ABBREVIATED PLAT AGENDA

August 6, 2025

STAFF REVIEW AND RECOMMENDATIONS
PUBLIC HEARING
AUGUST 6, 2025

ABBREVIATED PLAT: MORGAN COURT
LEGAL DESCRIPTION: SEC 10, T17N, R02W S.M., AK
PETITIONERS: THOMAS SMITH, RONDA SMITH
SURVEYOR/ENGINEER: LAVENDER / FROSTED GROUND ENGINEERING
ACRES: 4.97 +/- PARCELS: 3
REVIEWED BY: CHRIS CURLIN CASE #: 2025-97

NOTES
1. THE 2' CONTOURS SHOWN HEREON WERE DERIVED FROM PUBLISHED DATA OF THE MATANUSKA SUSTAINABLE BRIDGES
LOAD/IMAGERY PROJECT OF 2011/2012.
2. THE HORIZONTAL DATUM IS NAD83 (GEOGRAPHIC EPOCH 2003.0)
3. THE VERTICAL DATUM IS NAVD83 (GEOID00)

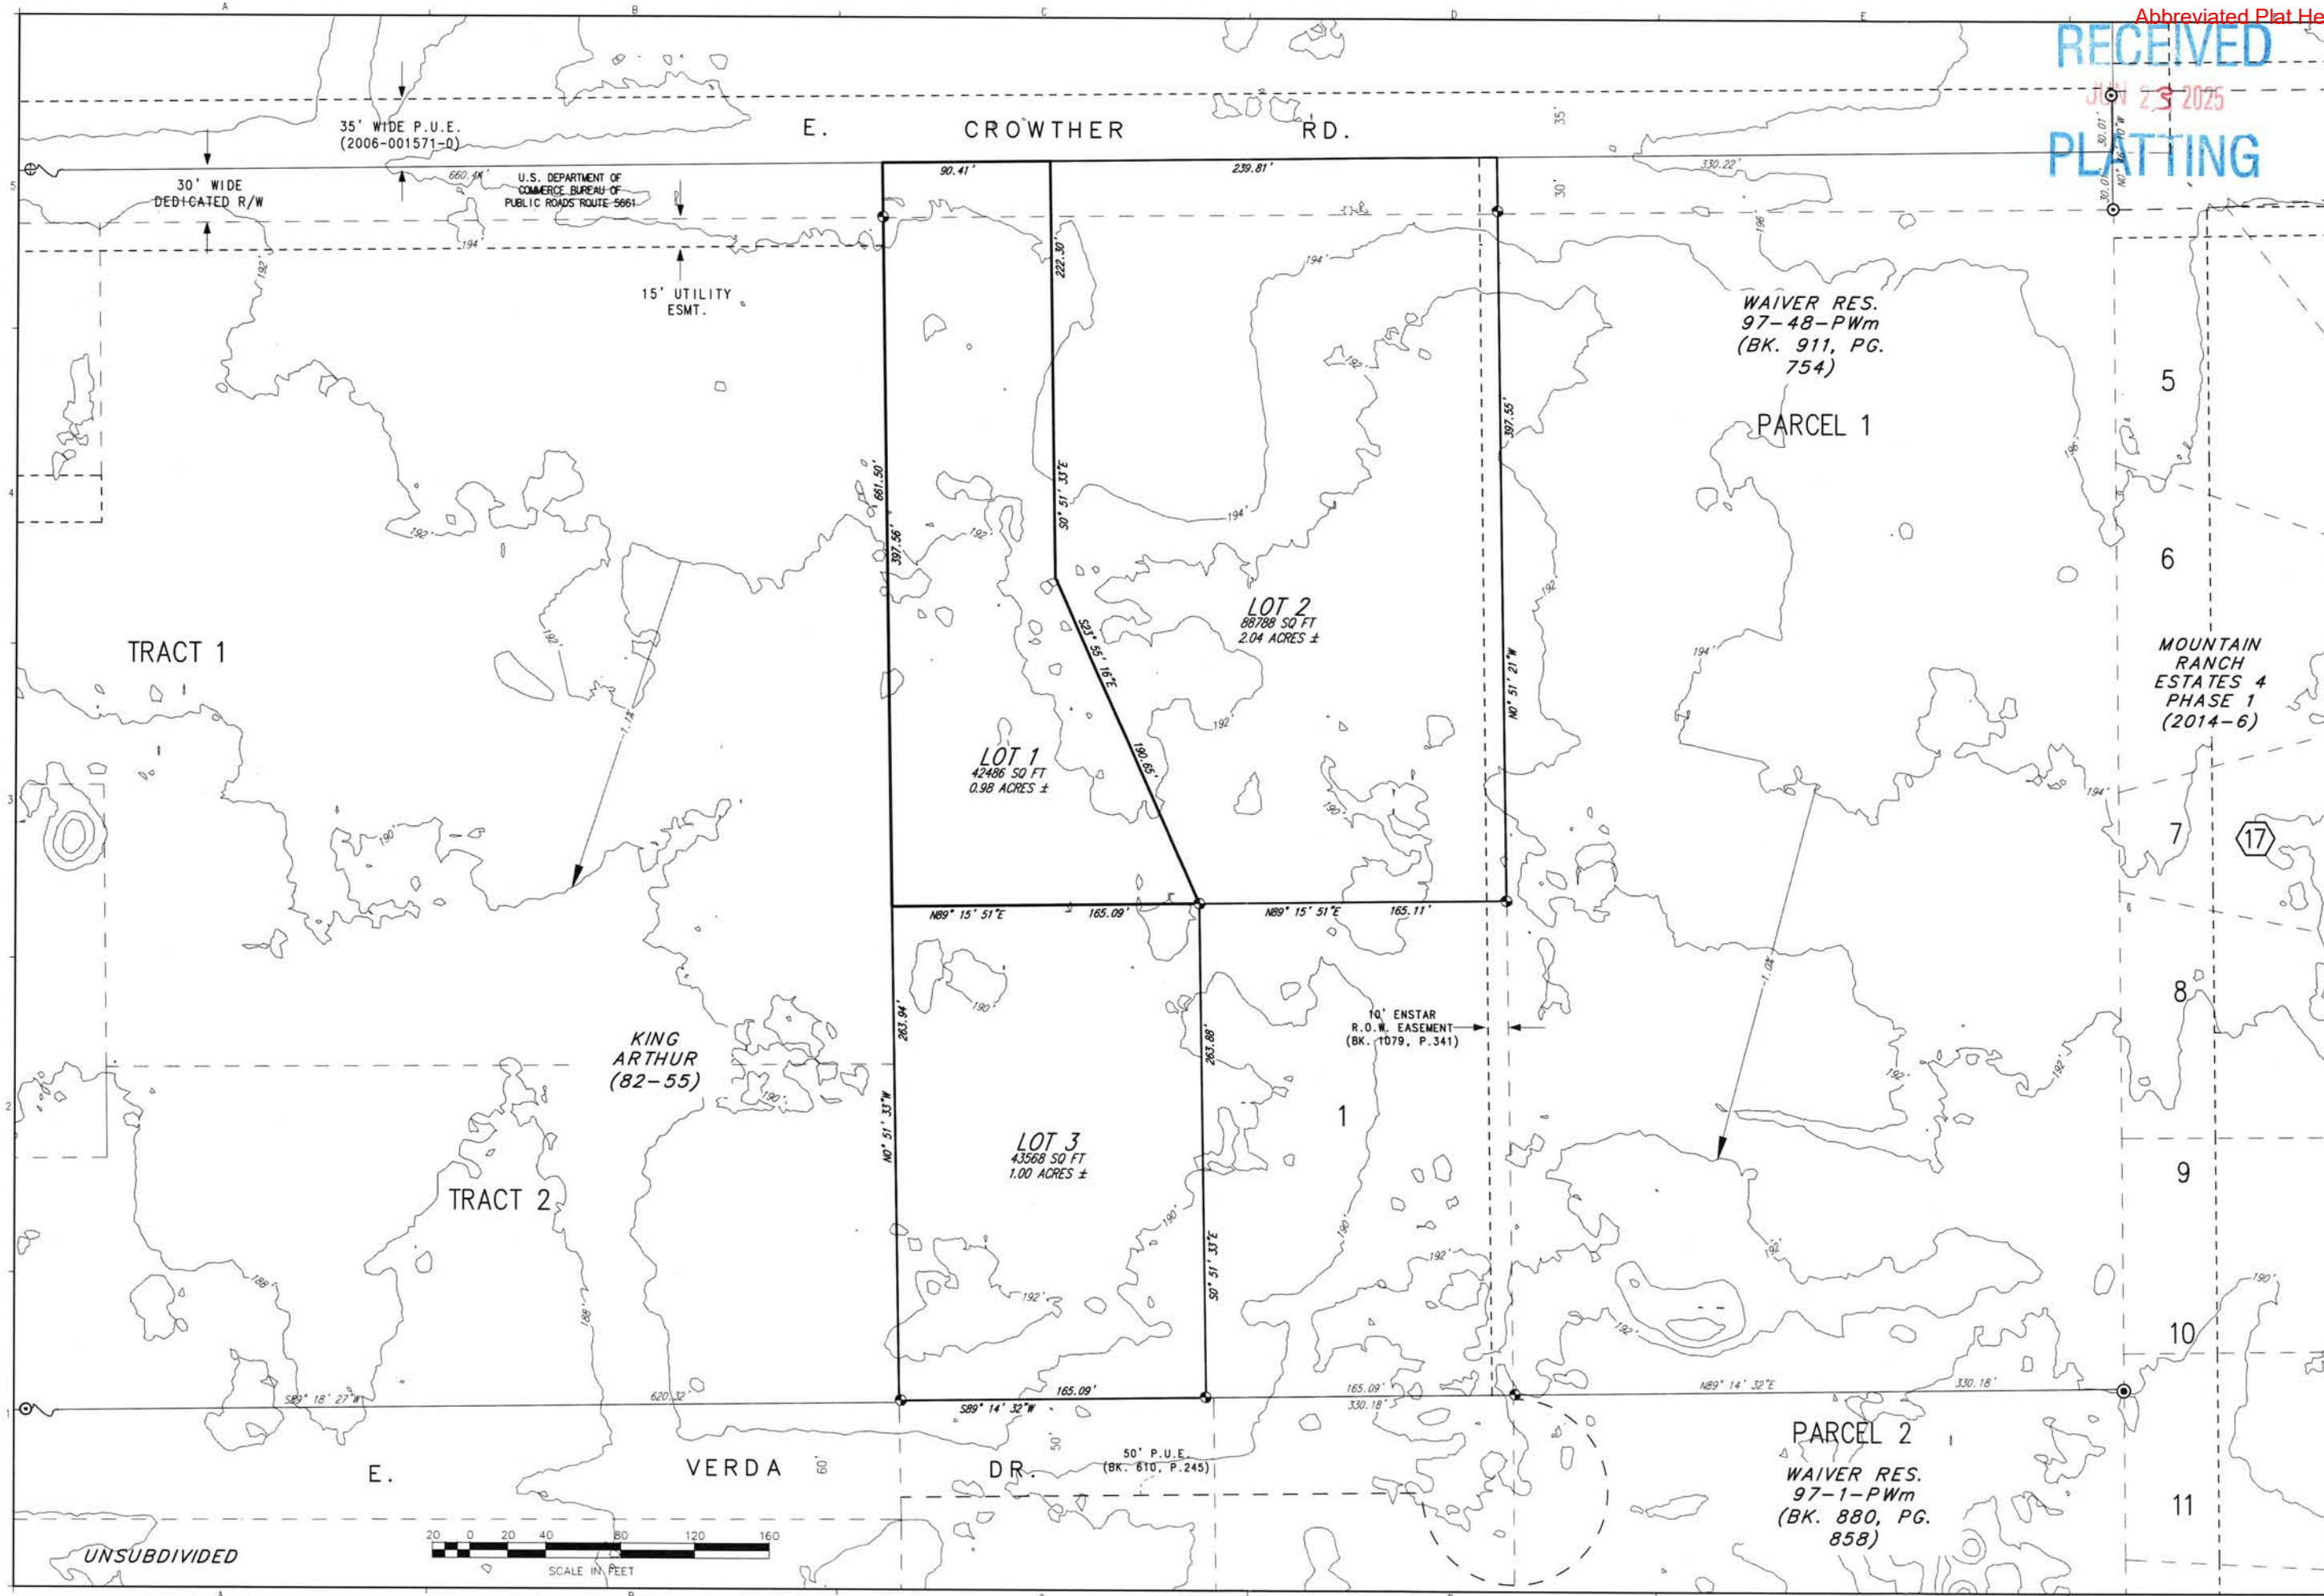
Concrete pad called out on the Site Plan is allowed to be within the proposed lot line and within the 10ft setback requirement as long as it is less than 18 inches above grade (MSB 17.55.004(A) definition of "structure".
